UNITED STATES PATENT AND TRADEMARK OFFICE

09/615,794

Dong-Gyu Kim

Office Action Summary

FIG. 10

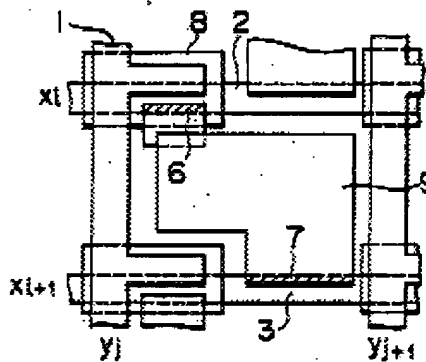
As to claims 1-3, Tsukada discloses in Figure 10 his fourth embodiment (col. 8, lines 38-62) a liquid crystal display, comprising:

a plurality of gate lines, 3, formed at the first substrate to transmit scanning signals;

a plurality data lines, 1, crossing over the gate lines to transmit picture signals;

a second insulating substrate facing the first substrate;
 a liquid crystal layer injected into the gap between said first insulating substrate and said second insulating substrate; and
 a storage capacitor, 7, formed between said pixel electrode and the previous gate line (col. 6, lines 40-48).

Tsukada does not explicitly disclose a black matrix defining each pixel; wherein an opening ratio of each pixel at the first pixel row is different from the opening ratio of the pixels at the other pixel rows and a protective layer formed over the gate lines and data lines with a plurality of pixel electrodes formed on said protective layer.

As to claims 9 and 11-12, Tsukada discloses in Figure 10 his fourth embodiment (col. 8, lines 38-62) a liquid crystal display, comprising:
a first insulating substrate;
a plurality of gate lines, 3, formed at the first substrate to transmit scanning signals;

a storage capacitor, 7, formed between said pixel electrode and the previous gate line (col. 6, lines 40-48);

FIG. 1

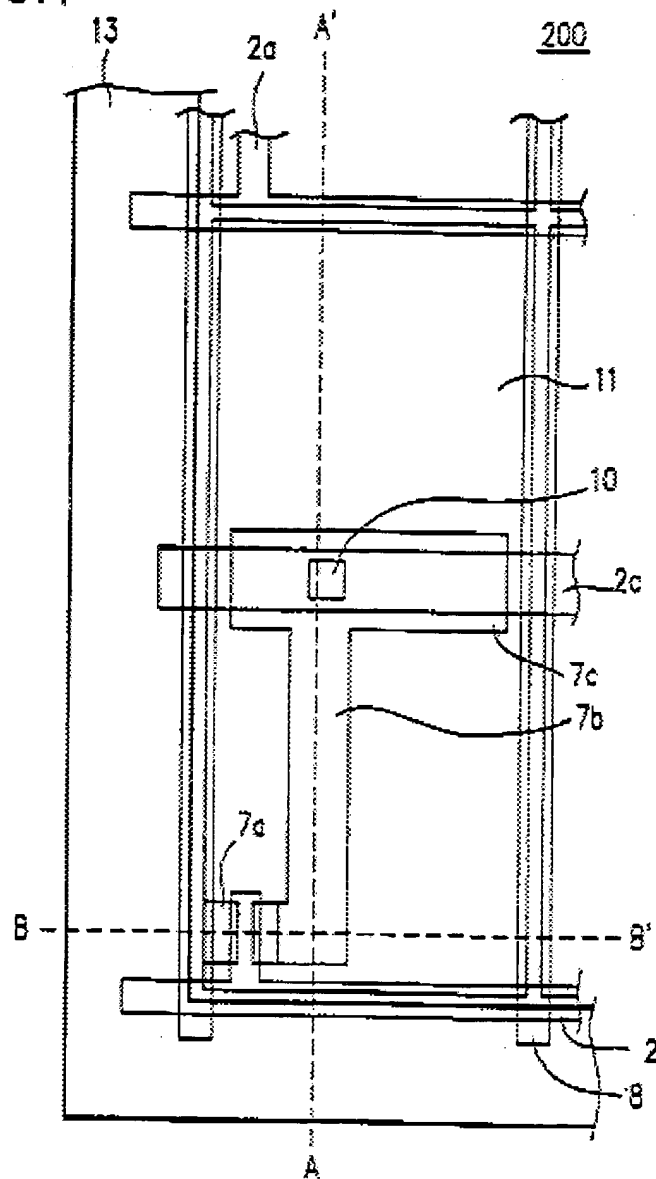
Shimada teaches (Title, Abstract, entire patent) a liquid crystal display (LCD) panel comprising:

a first substrate provided with a plurality of gate, 2, and data, 8, lines, the gate lines being arranged to cross the data lines to define a plurality of pixel regions in a matrix arrangement; a second substrate provided with a black matrix layer (col. 5, lines 50-60) to shield portions other than the pixel regions from light; and liquid crystal layer injected between the first and second substrates, wherein the pixel regions in a peripheral portion of the matrix arrangement has an aperture ratio lower than that of the pixel regions in other portions of the matrix arrangement (col. 2, lines 2-12 and col. 6, lines 35-45) in the example where the black matrix overlaps the pixel electrodes, 11 (col. 2, lines 29-42), in areas where no gate or data line exists to prevent light leaks in areas where no gate or data line exists despite mating substrate misalignment.
